Addendum No. 1

**Shade Structure Installation at Dunsmore Elementary School
Bid No. 157-17/18**

PD1.0

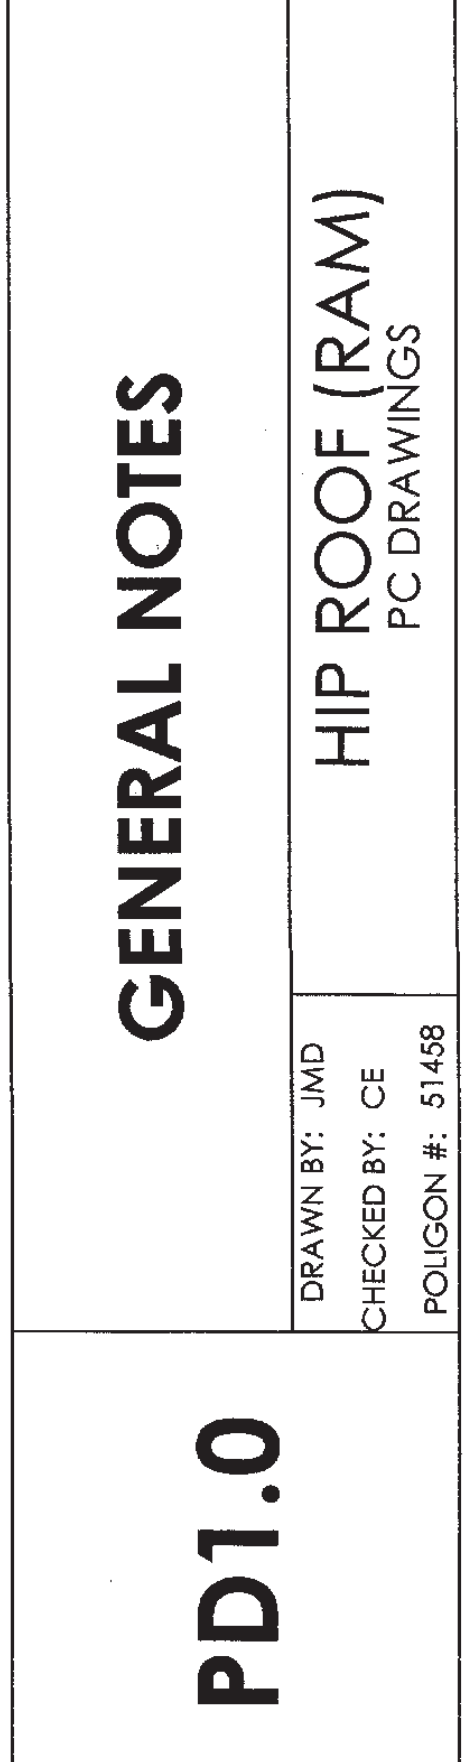
- 1) Concrete footings: Sheet # PD2.0: the plans is directing us to use detail # 1 on the same sheet but the detail # 1 is crossed and there is a different detail # 2 for the same purpose. Which one we are going to use. Please advise.

Response: *Based on the attached filled out coversheet (PD1.0), the selected foundation option in step #6 was drilled pier so detail 2 is the correct foundation type.*
